## **Bid Addendum No. 1 for:**

### **MASON TRANSIT AUTHORITY – PARK AND RIDE CONSTRUCTION PROJECT**

All Bidders are required to make the following substitutions to the Bid Documents. Below is a description of the revisions made to the Contract Documents.

DRAWING No.:  
SP-5

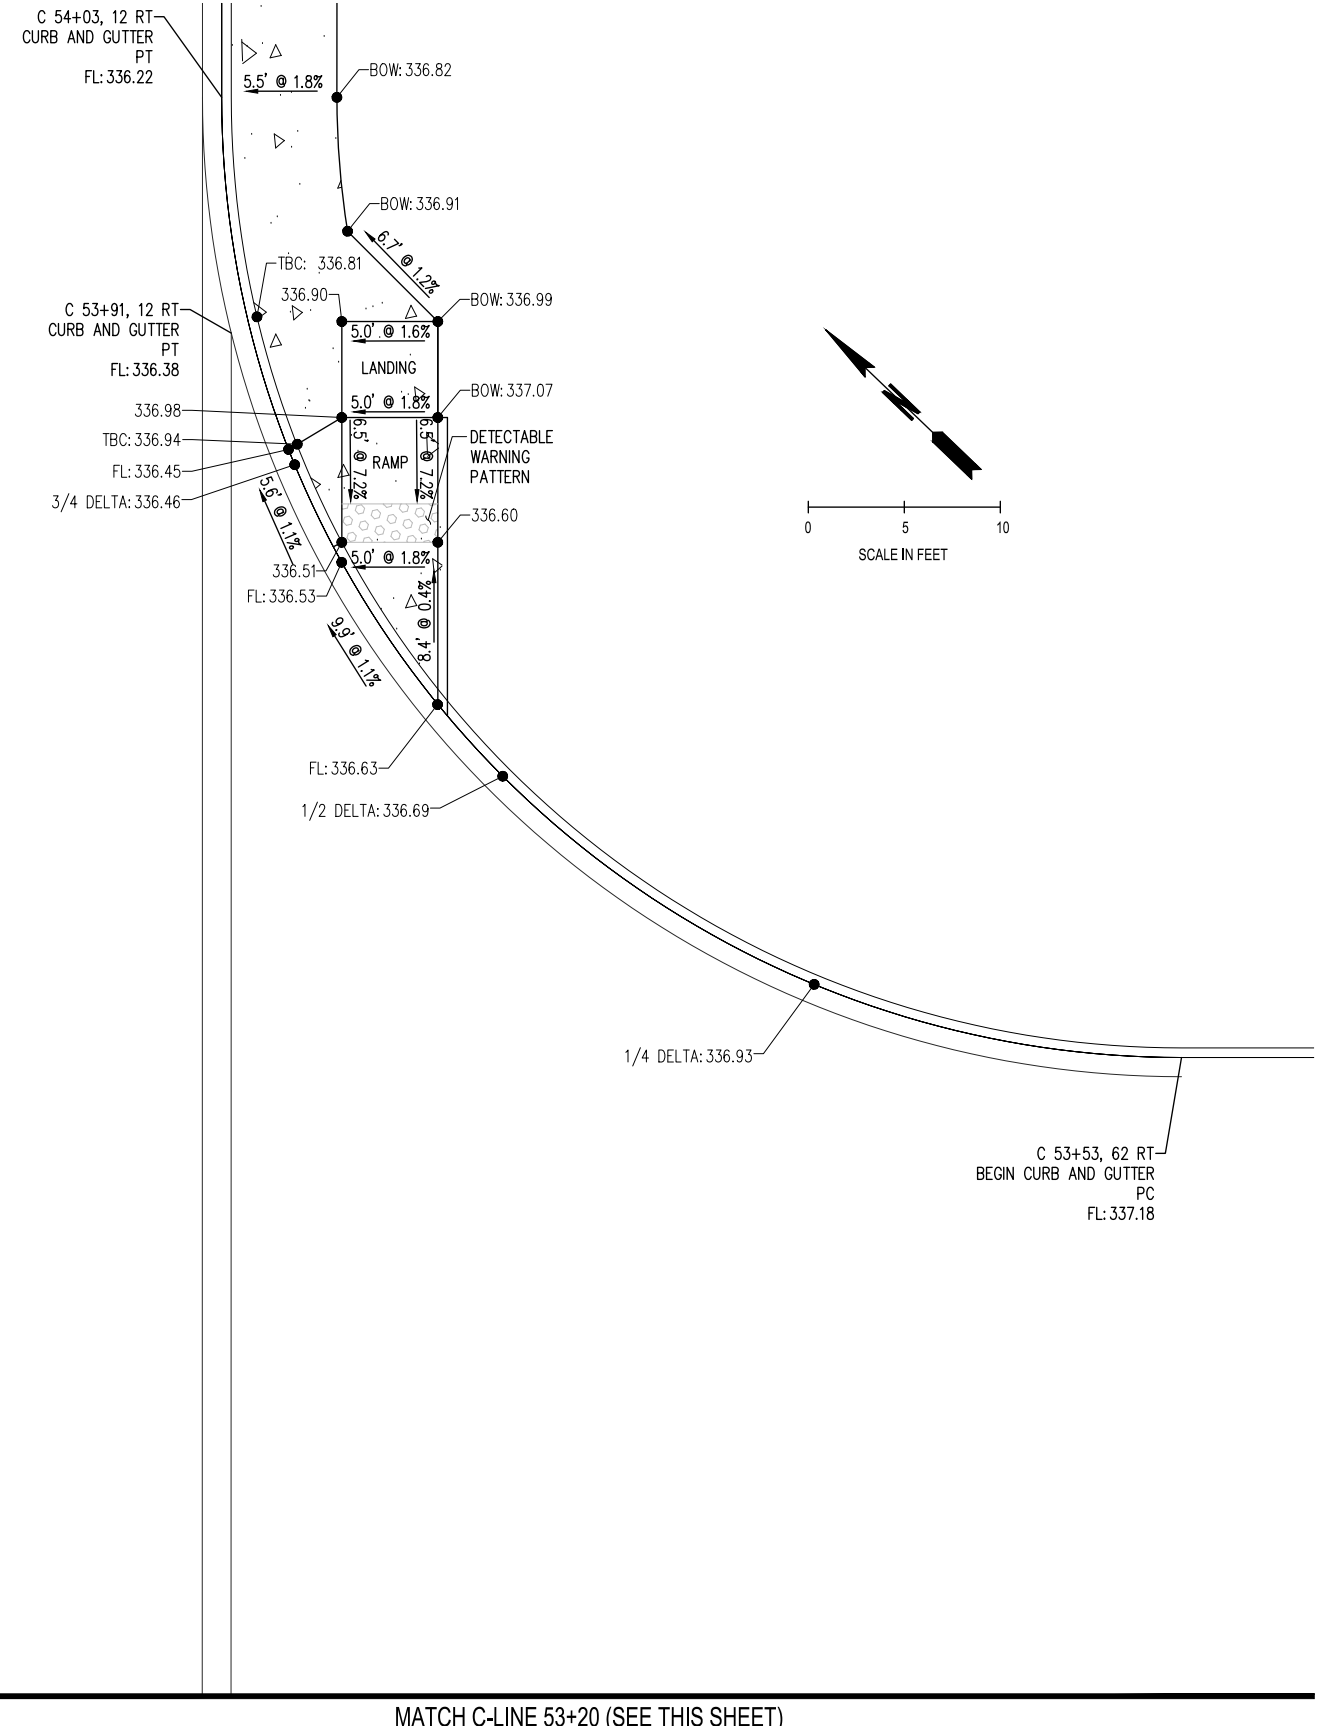
- Sheet SP-5 to SP-6: Added reference only note.
- Sheet PP-1: Added reference only note.
- Sheet PM-1: Added reference only note.
- Sheet WA-1: Replace with attachment WA-1 to include updated water plans
- Sheet WA-4: Replace with attachment WA-4 to include enlargement detail
- Sheet M3.1, General Note: **ADD** note:
  - 5. Fire sprinkler contractor to provide backflow assembly per code for fire sprinkler system in fire riser room 112.

FOR REFERENCE ONLY  
CONSTRUCTED AS PART OF THE  
LOG YARD ROAD ROUNDABOUT  
CONTRACT

DRAWING No.:  
PP-1  
SHEET No.:  
14 OF 86

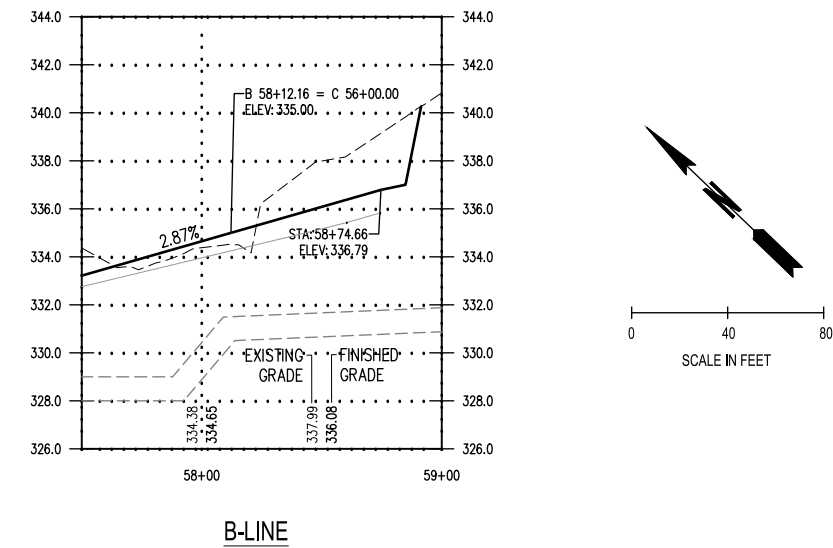
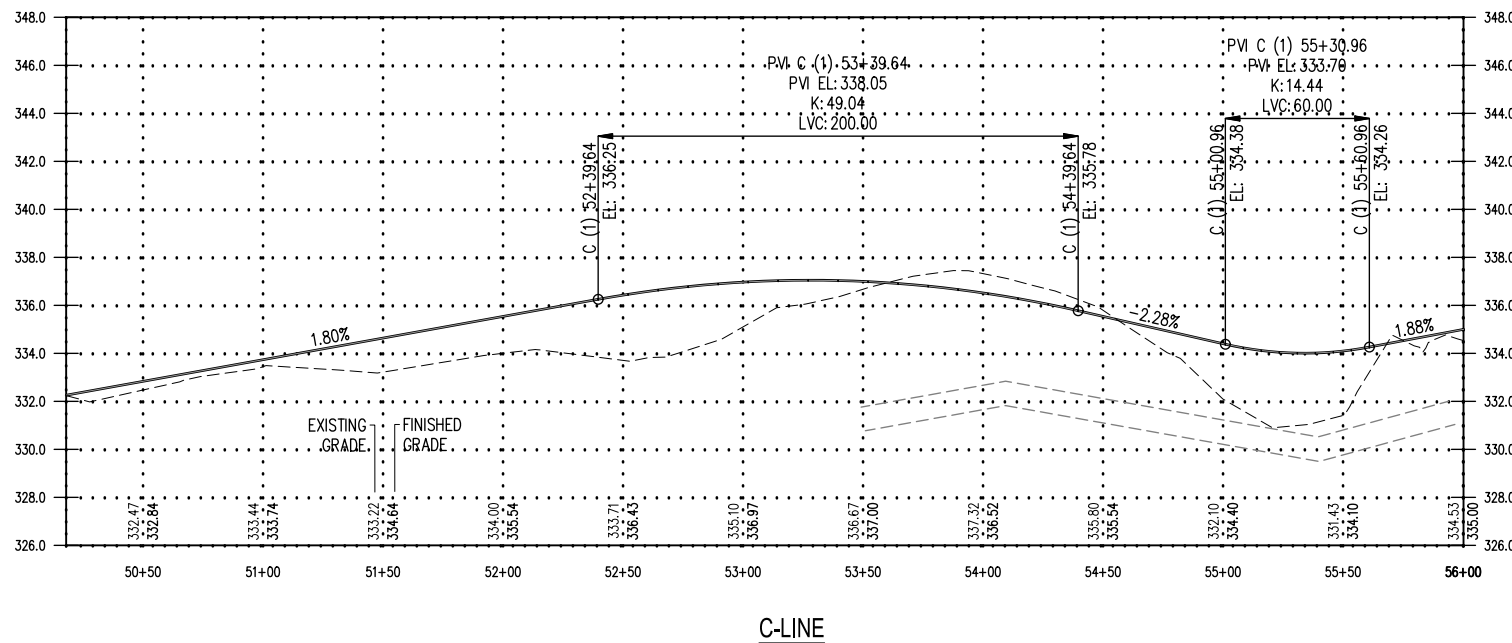
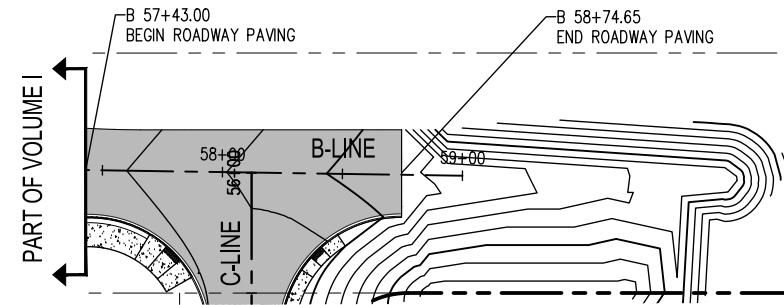
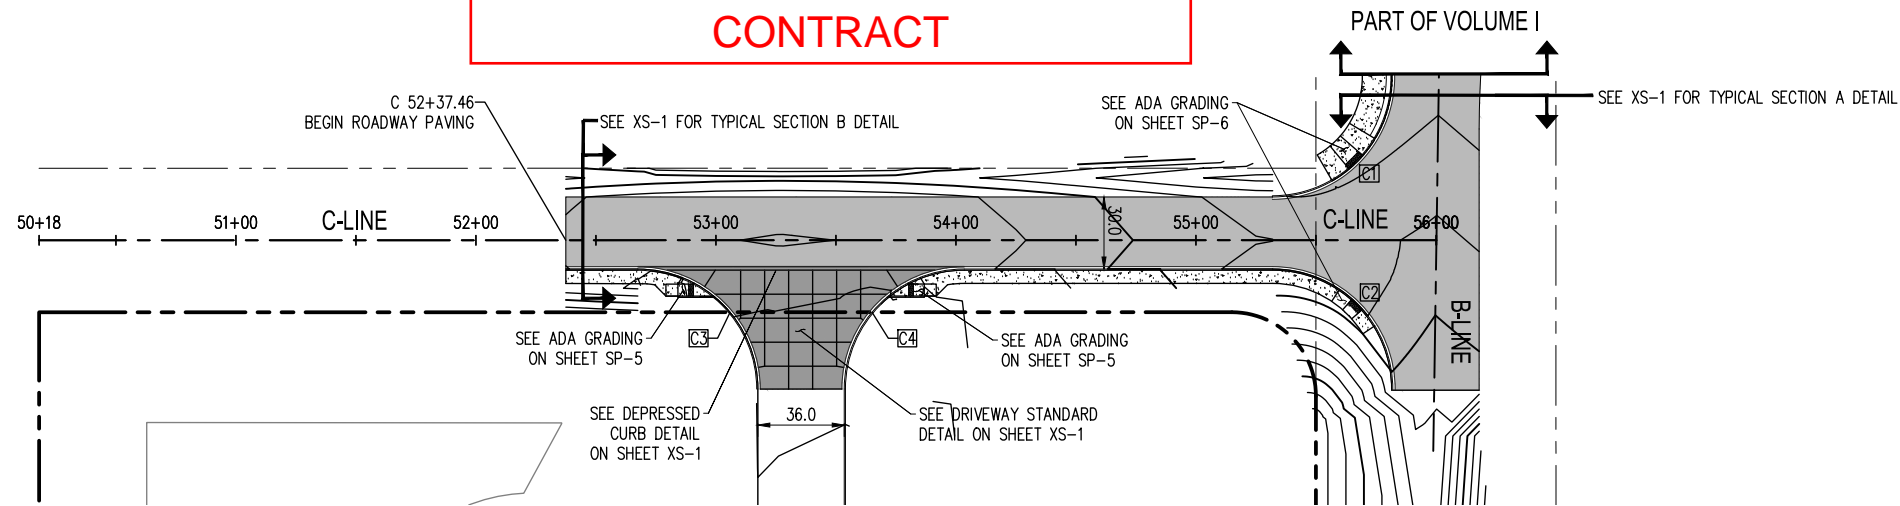
FOR REFERENCE ONLY  
CONSTRUCTED AS PART OF THE  
LOG YARD ROAD ROUNDABOUT  
CONTRACT
